Approved Street Marker Paver Circle Identification Middle Beach Recreational Corridor

Paver Circle Design with Street Markers
Modification Approved by the City
Middle Beach Recreational Corridor

MBRC - PHASE II
CITY OF MIAMI BEACH - CIP OFFICE
CITY OF MIAMI BEACH, FLORIDA
SITE PLAN APPROVAL SET - NOT FOR CONSTRUCTION

RECEIVED
02/24/2017
DIVISION OF WATER
RESOURCE MANAGEMENT
DA-659 M1

TYPICAL CIRCLE
PAVER
PATTERN DETAIL

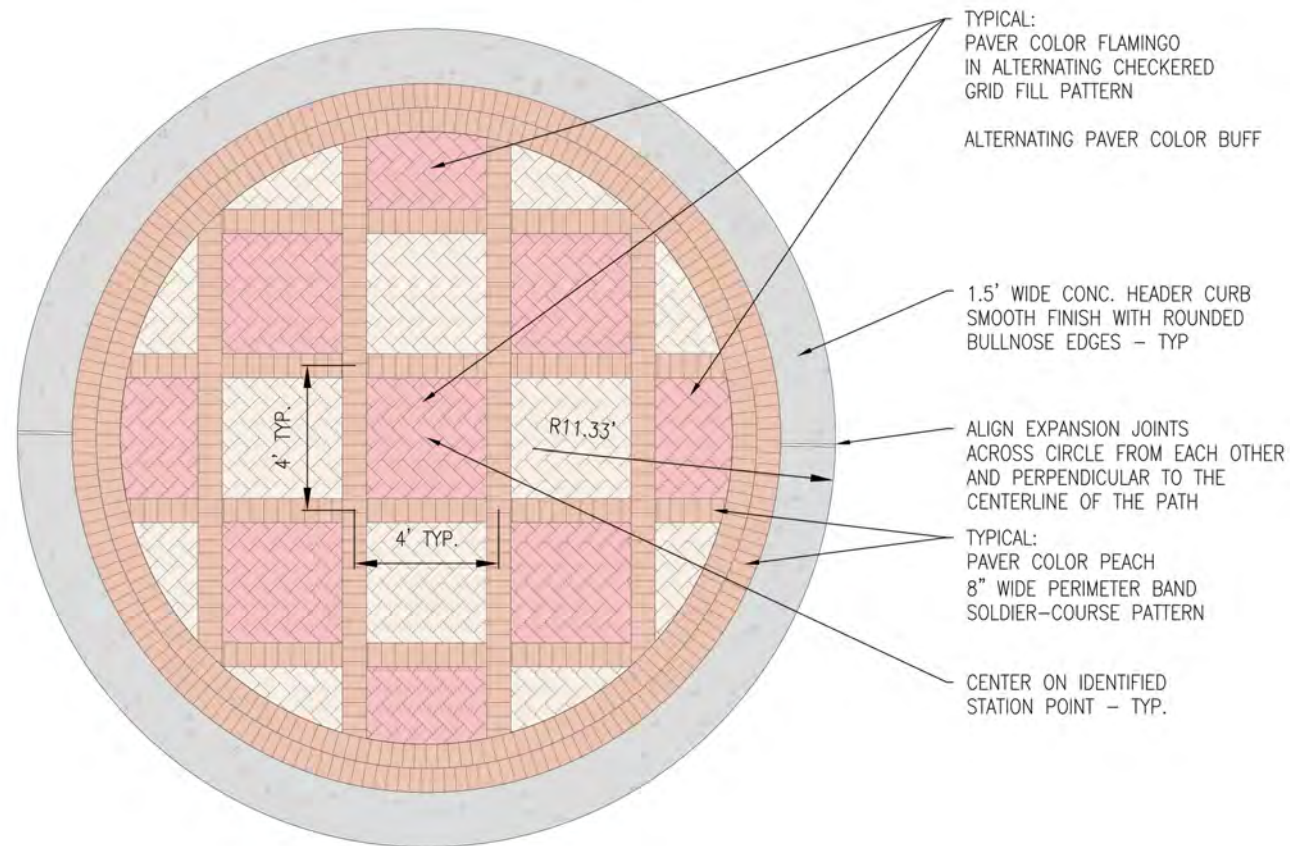
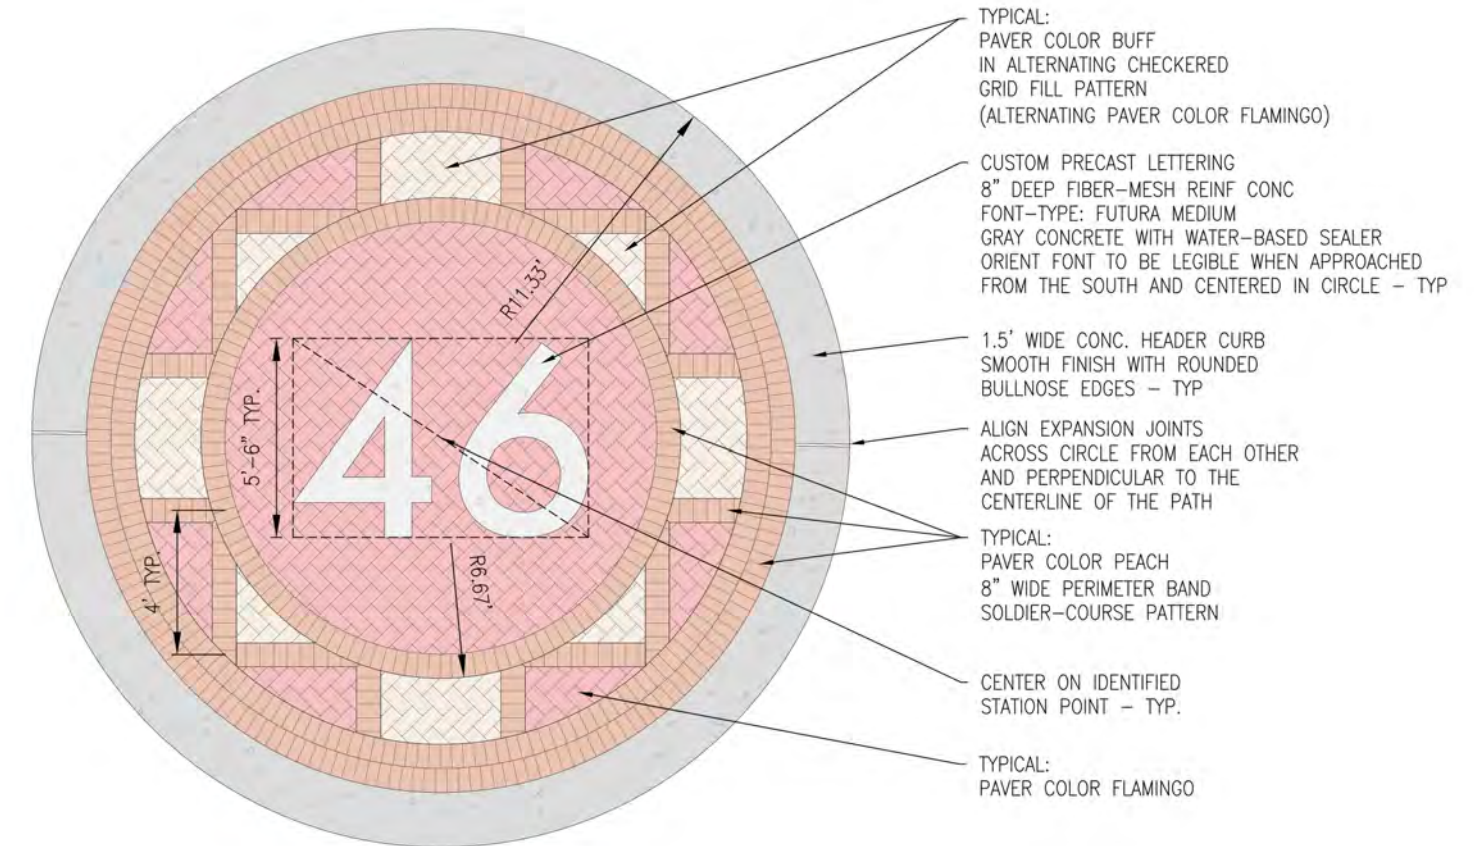
Paver Circle Design
Per Permit Plans
Middle Beach Recreational Corridor

TYPICAL CIRCLE
PAVER
PATTERN DETAIL

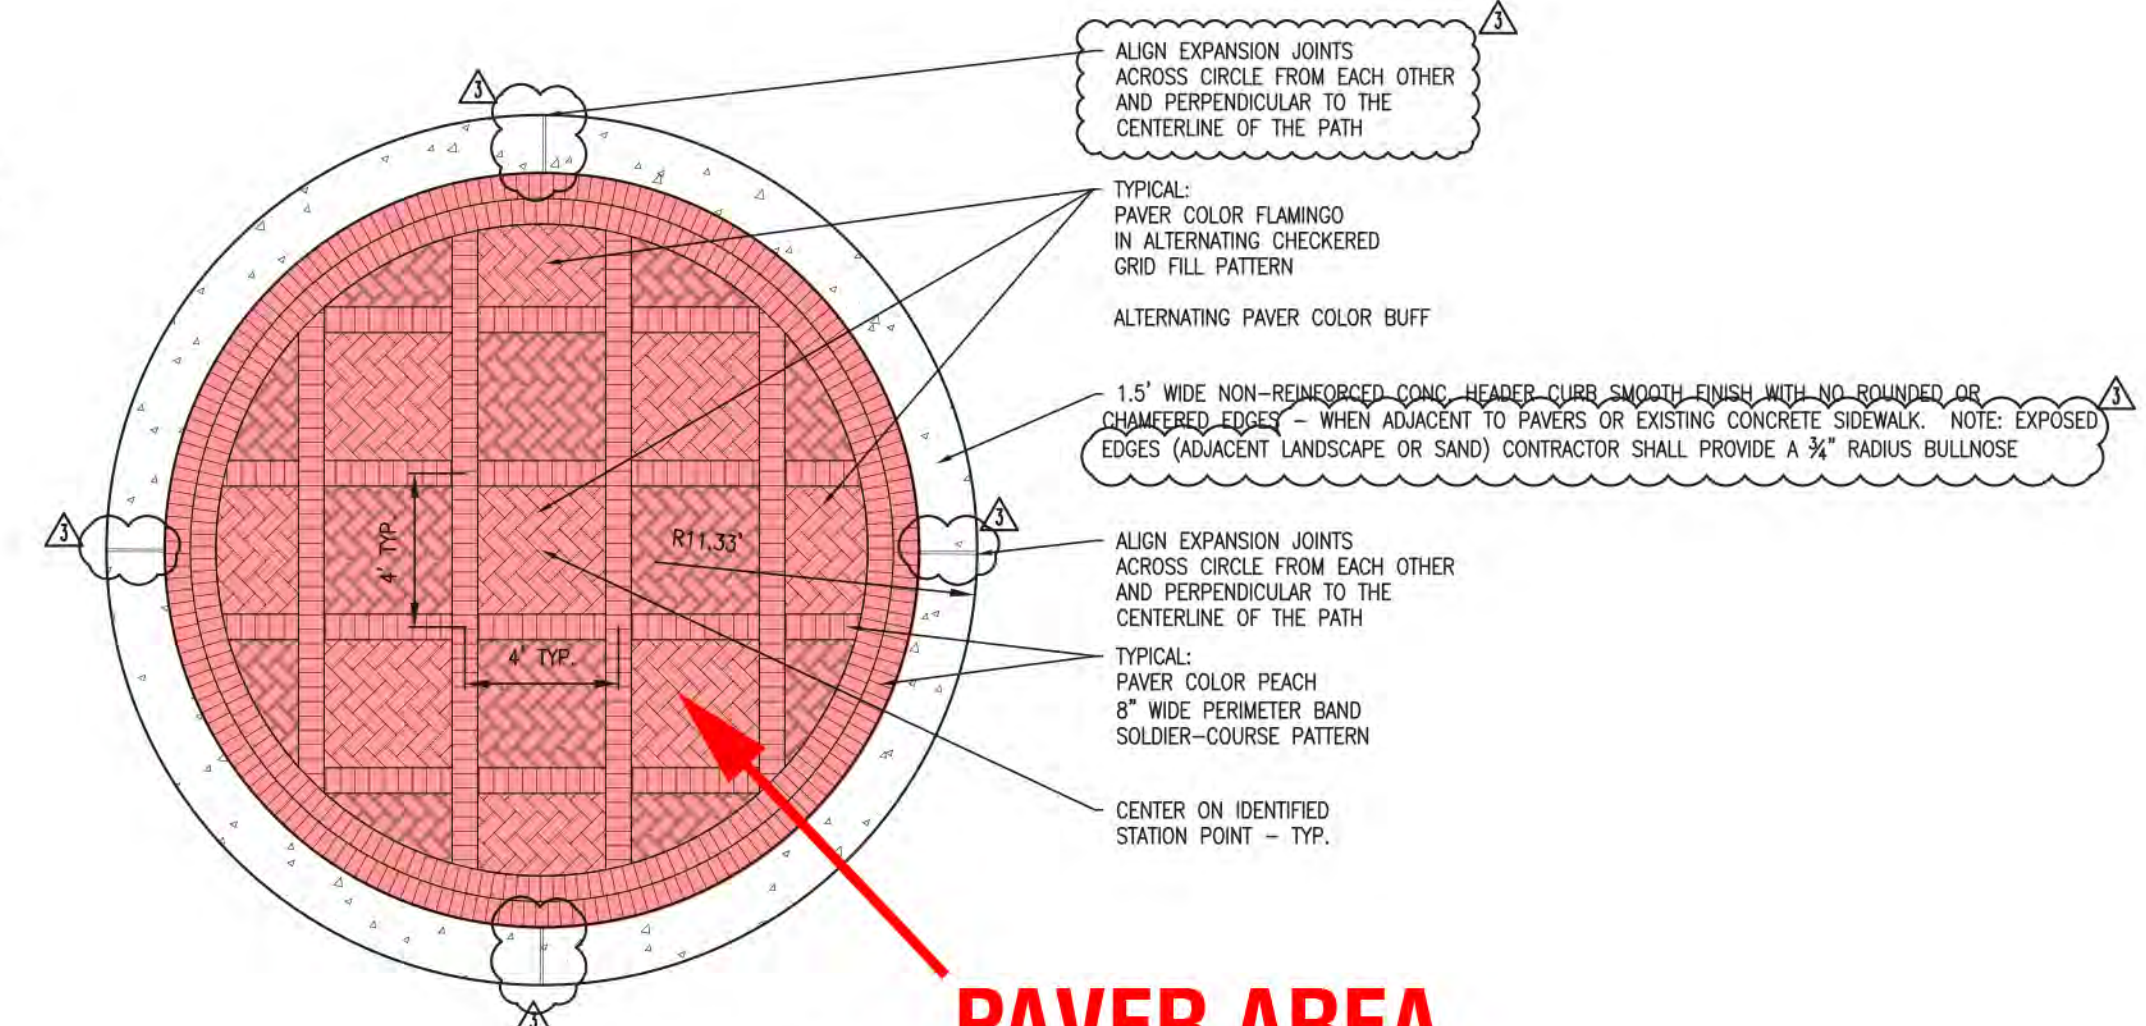
PAVER AREA
TO BE
MODIFIED
